Subject: Re: Submission to Application Number DA2021/0744

As the owner and resident of 30 Dowling Street I like to make a submission regarding the proposed development application 2021/0744.

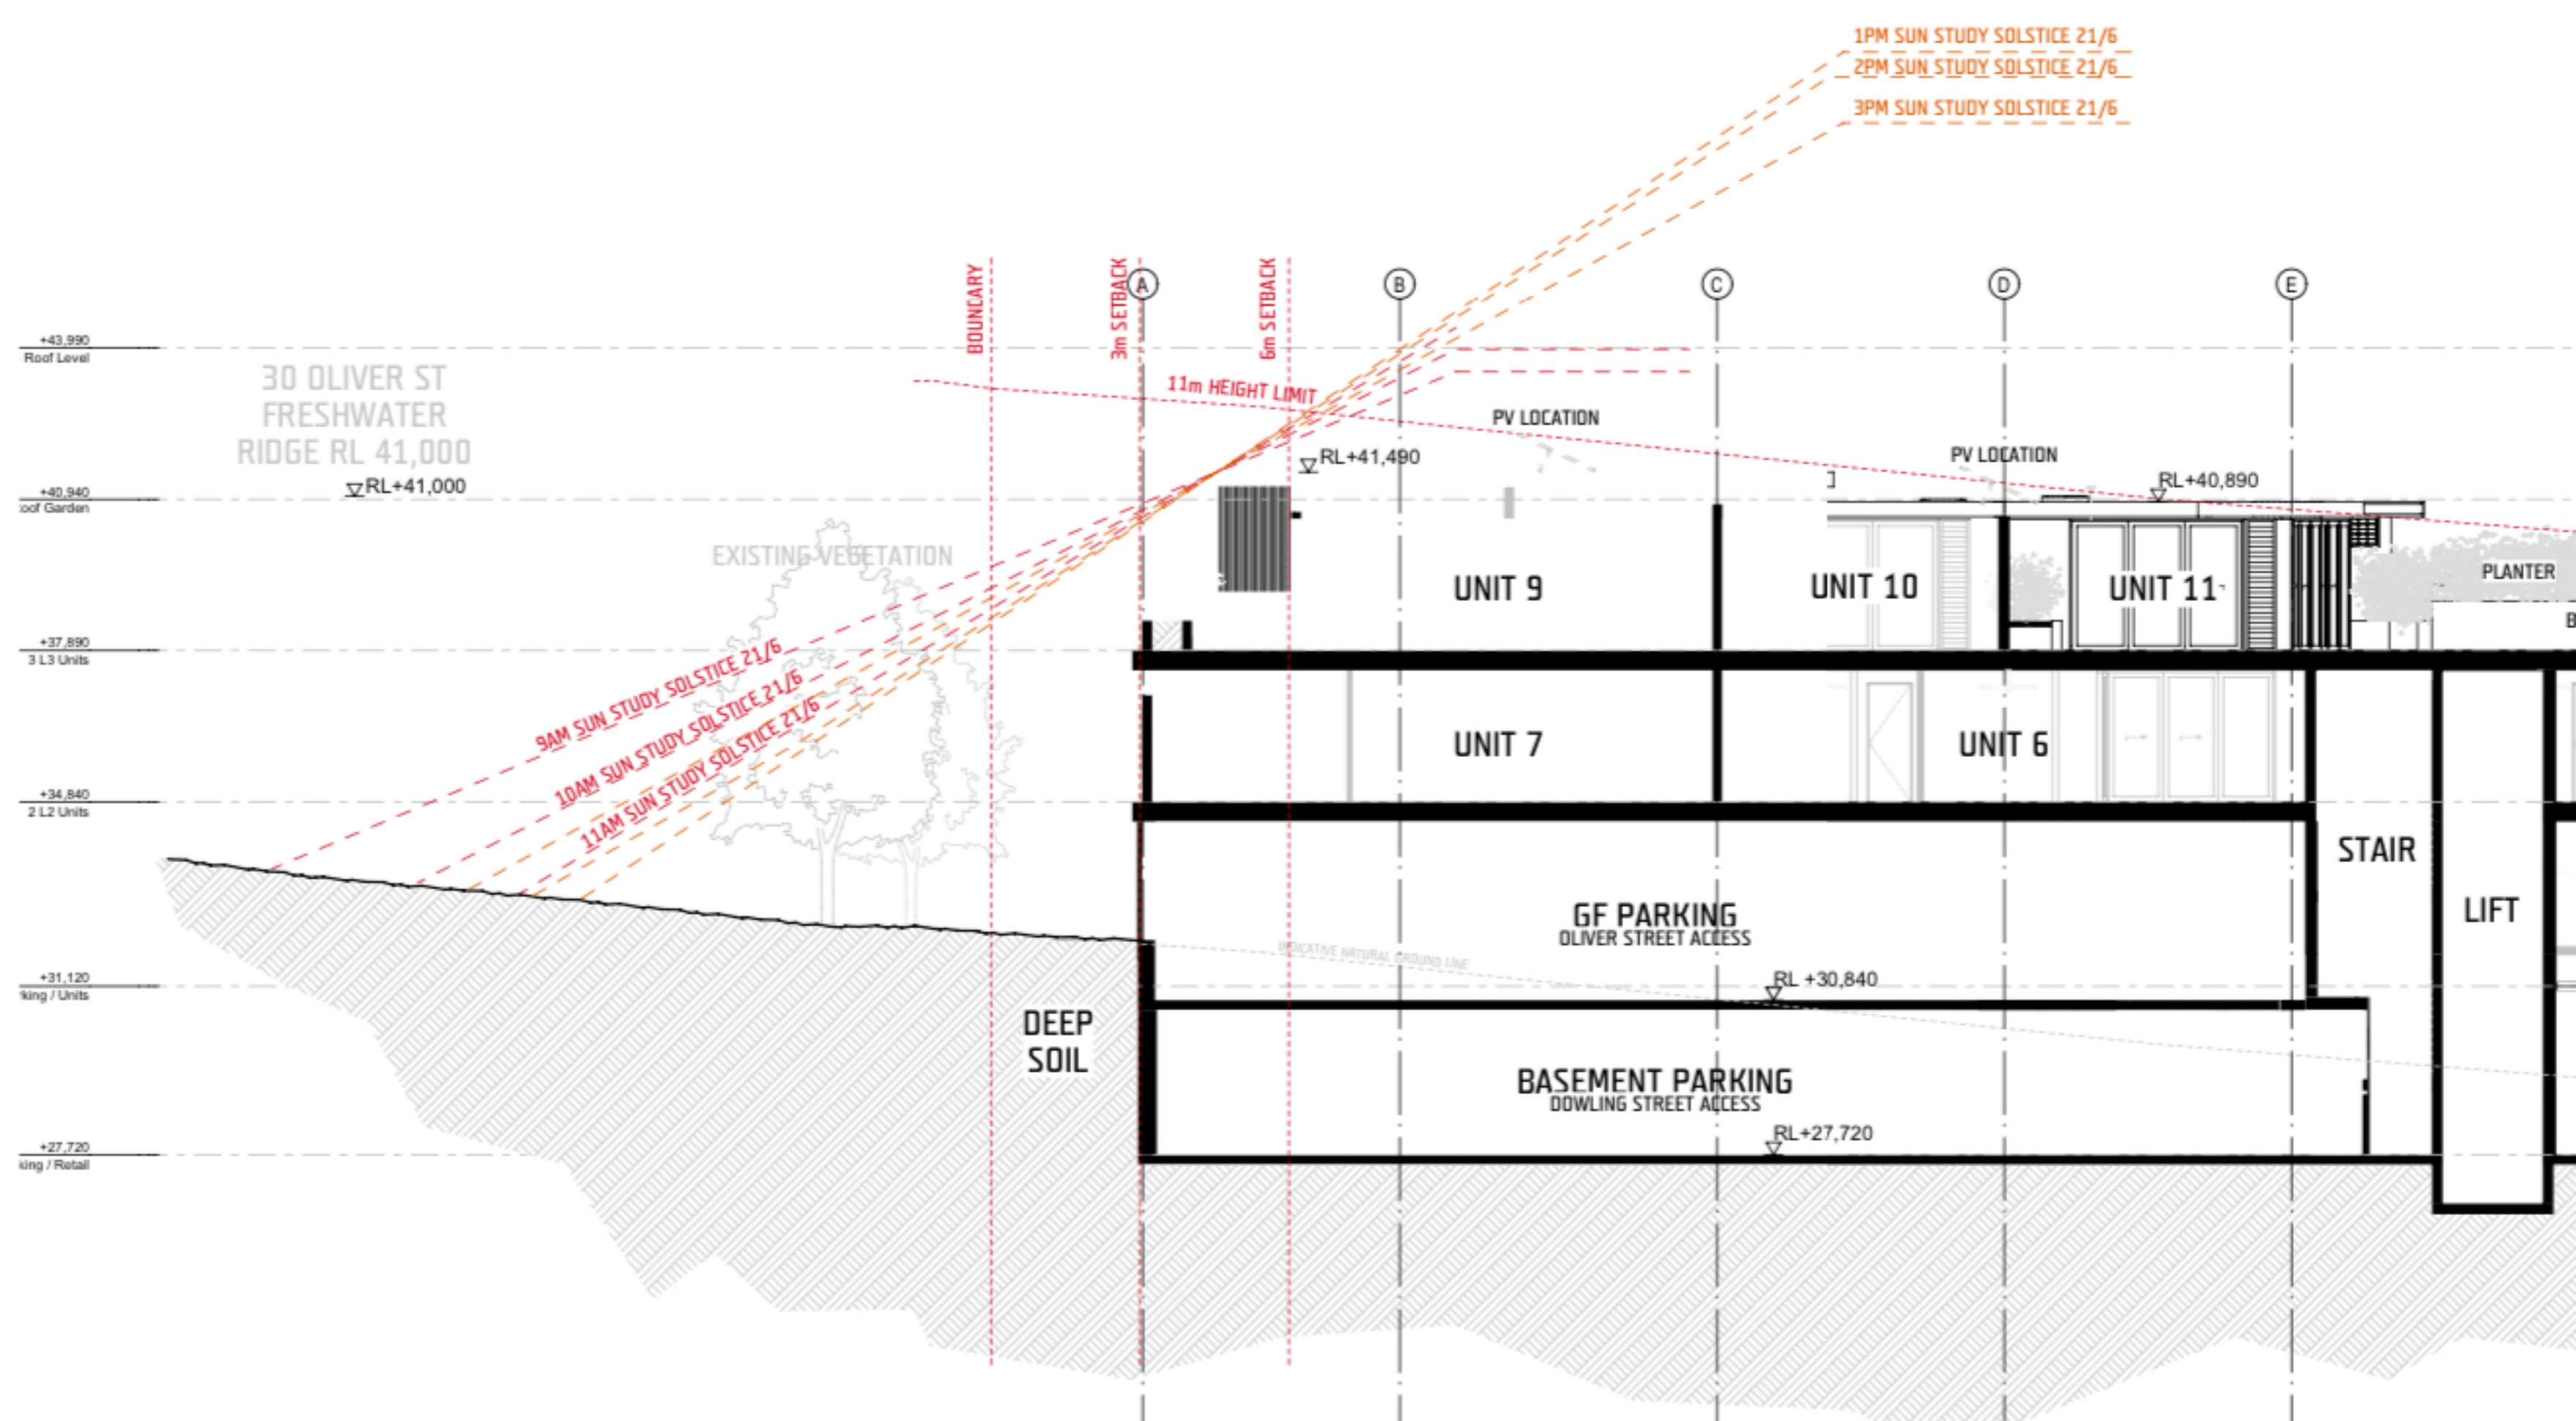
An adjacent power pole (which is shorter than the proposed height of the development) provides clear evidence that during the day the shadows will extend from over 20 metres in the morning, to a minimum of 14 metres at midday over the property line with all direct light lost by 4pm due to the overshadowing by the unit block to the West.

The almost complete removal of sunlight will render this now beautiful garden area incapable of sustaining plant life. It will become a dark, cold, wet uninhabitable area as the existing plants die off. No plants will be able to regenerate without light or warmth and as the current garden dies the development will be even more visually prominent. During Winter 1/3 of our entire land will receive no sunlight at all, and that's when it needs it most to dry the rain and damp. I have attached photos taken yesterday that clearly show my claims of shadow length at various times of the day.

Pages 17/18/19 of the Master Plan show shadow modelling images that are a wild misrepresentation. Page 18 purports to show very short shadows in June , my attached images taken on 27 June indicate shadows of 20 metres at 10 am.
